| PROJECT | 2X660 MW UDANGUDI SUPERCRITICAL TPS, STAGE-1 |

| 400 KV SWITCHYARD AT UDANGUDI SUPERCRITICAL TPS STAGE-I (2X660 MW) | | |
| Clarification for & Architectural dwgs. GIS Building (Plans,Elevations & sections) | | |
| BHEL DWG/DOC NO.: | TB-1-400-607-640-1,2 & 3 | |

ELEVATION - 1

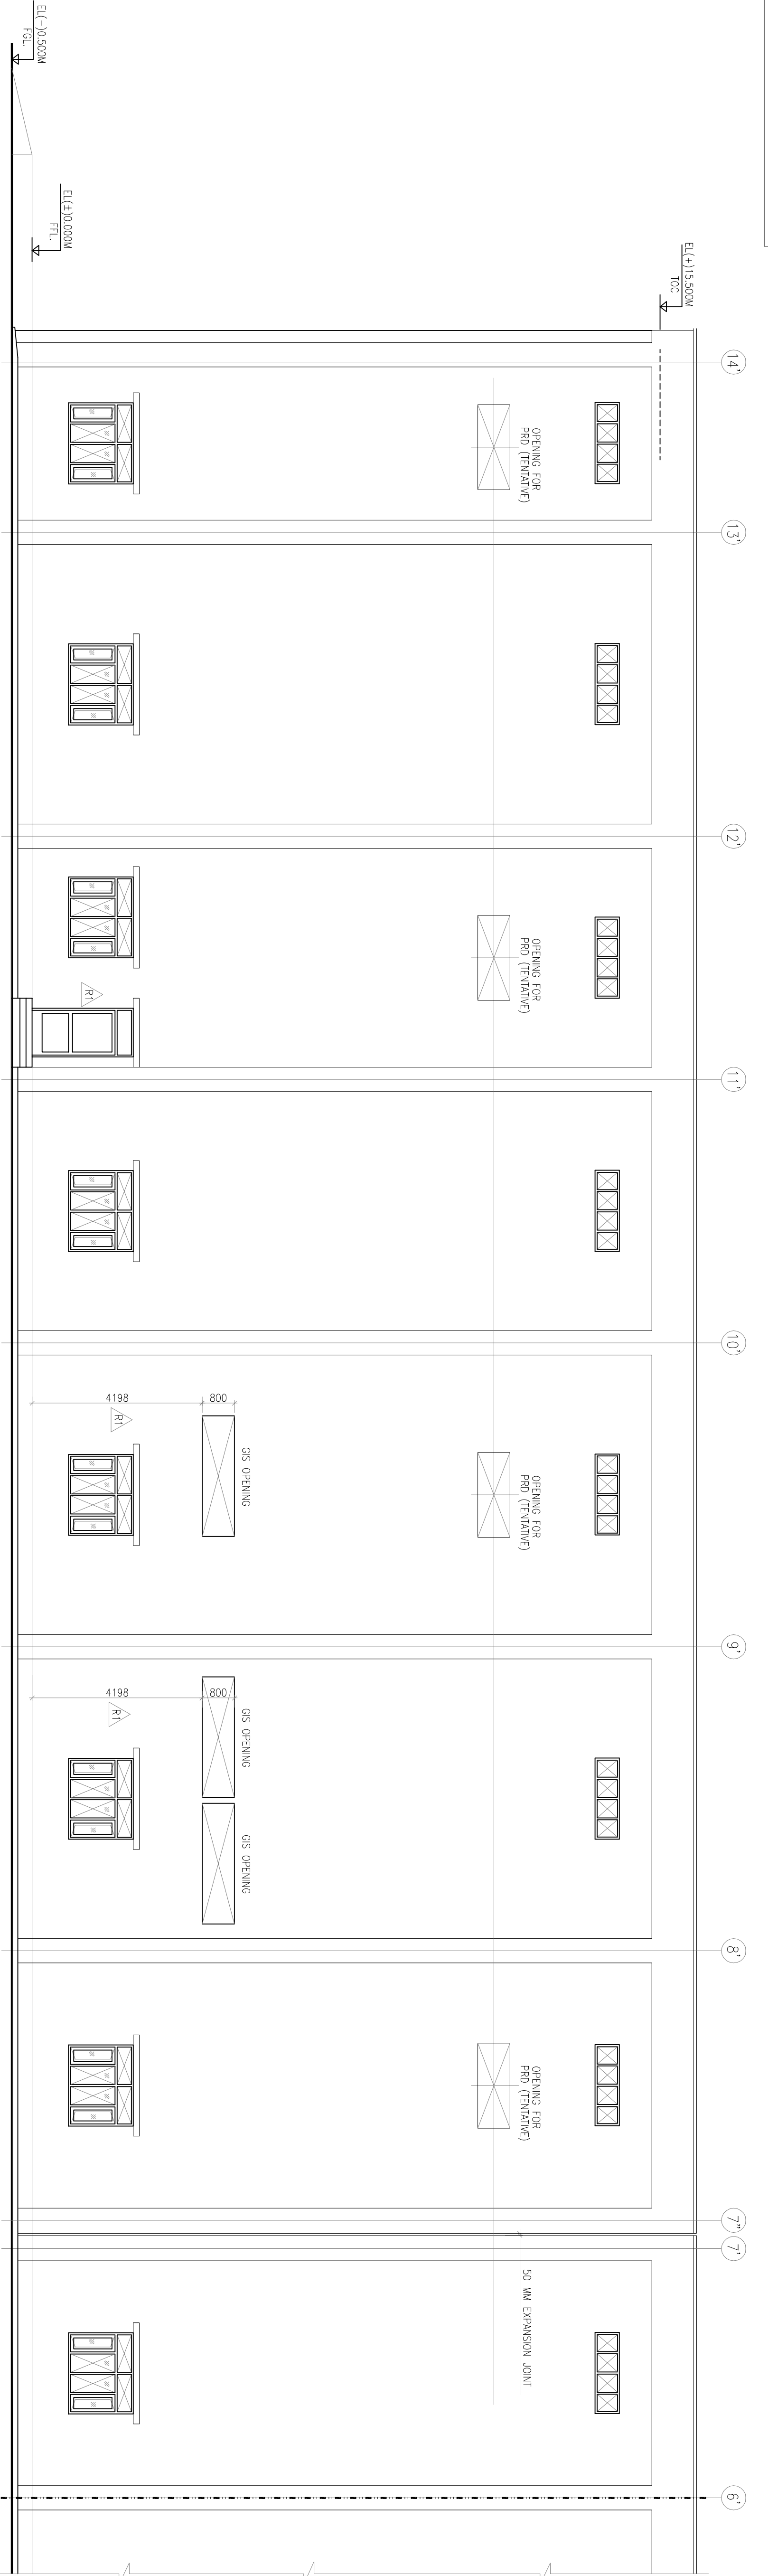
TANGEDCO comments - Add 2 numbers ventilator
(4 Nos+2 Nos) in all bays to increase lighting
